ENGINE - POWER PLANT - EEC HARNESS WITH ADDITIONAL ANTI-CHAFE PROTECTION IN THE AREA OF
THE LIGHTNING-STRIKE PROTECTION SLEEVES - CATEGORY CODE 6 - MOD.ENG-72-0256

- (1) Aircraft: Airbus A320
- (2) Engine: V2500 A1-Engines prior to Serial No.V0146

V2500-ENG-72-0256

Location of EEC harness tape
Fig.1

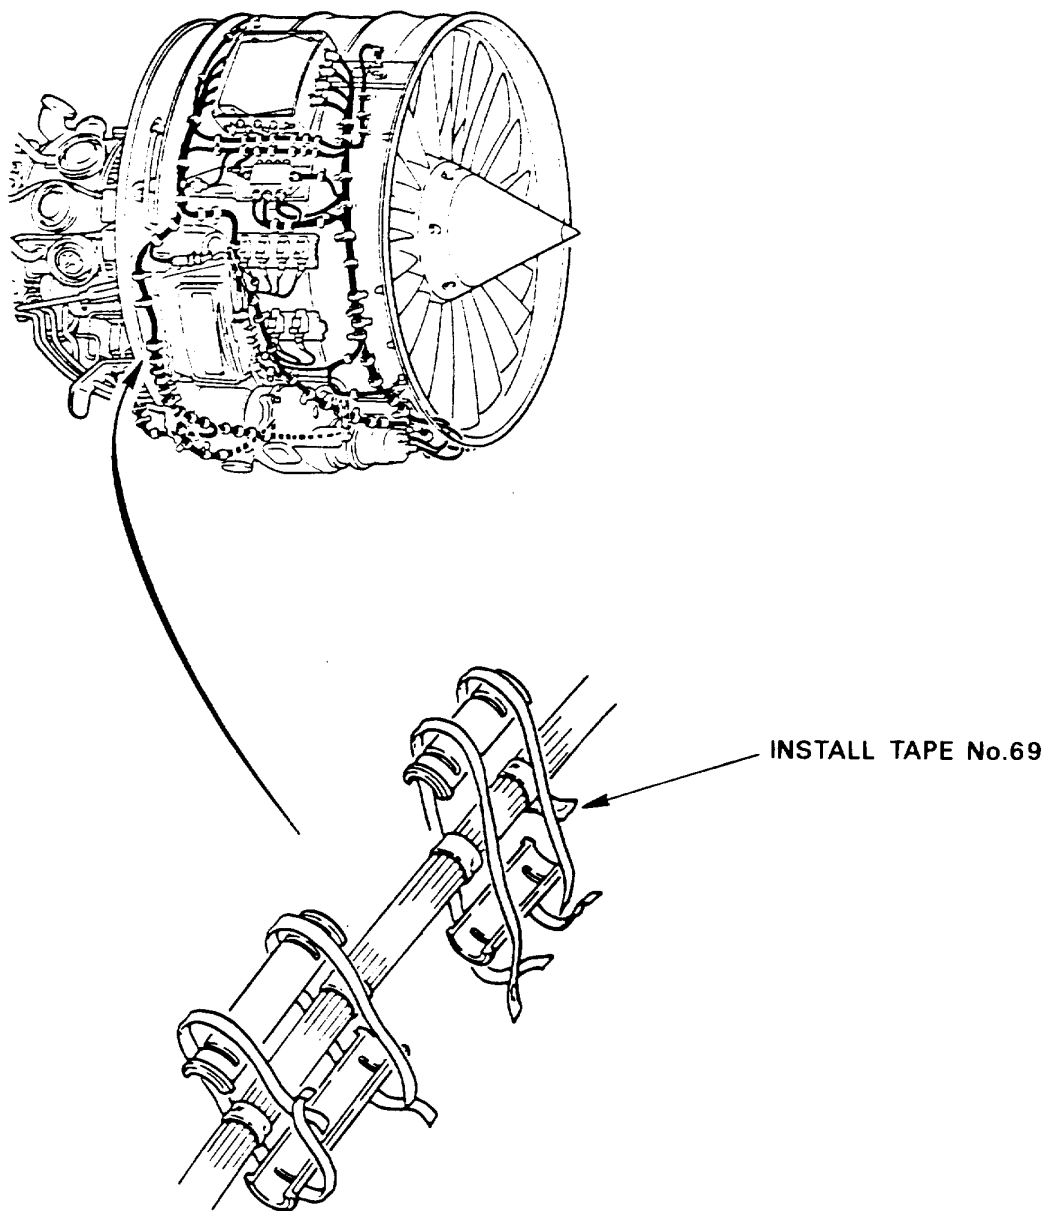
- (a) Re-inforced silicone rubber tape is put on the harness between clipping points 0535 and 0538. The tape covers the complete length of the harness contained within the sleeves and goes 25,4 mm (1.000in.) past the ends of the sleeves.
- (b) The tape is secured at both ends with two turns of Scotchboy 69 (U320585) tape 25,4 mm (1.000in.) wide.
- (c) Installation of the silicone tape prevents the shield ties being laced thru the harness wires as currently specified. The ties are now wound around the tape.

(9) Remove 718G lacing tape from the lightning strike protection sleeves at 4 positions	Refer to Figure 1
(10) Remove the split sleeves PN5A9345 (2 off), PN5A9342 (2 off) and the scotchboy tape No.69 from the EEC harness at 4 positions	Refer to Figure 1

View on lightning strike sleeves - After alteration
Fig.2

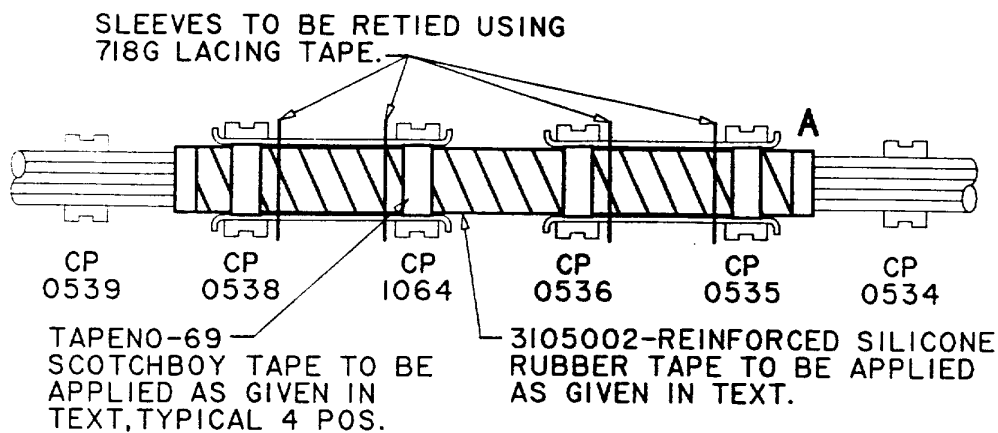
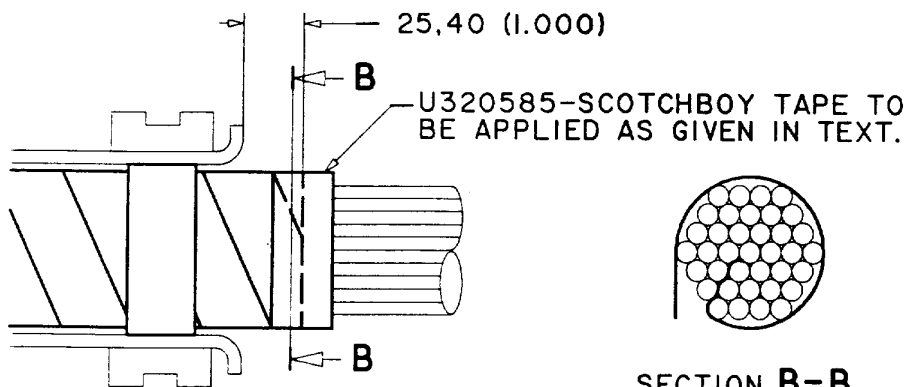
| (11) Apply the re-inforced silicon rubber tape PN3105002 onto the EEC harness. Weave into harness and wind silicon rubber tape the complete length as marked | Refer to Figure 2 |
| (12) Secure the silicon rubber tape at both ends with two turns of scotchboy tape PNU320585 | Refer to Figure 2 |
| (13) Mark the four clipping points 0538, 1064, 0536 and 0535 on the silicon rubber tape | Refer to Figure 2
| (14) Apply scotchboy tape No.69 at four clipping points as marked | Refer to Figure 2 |
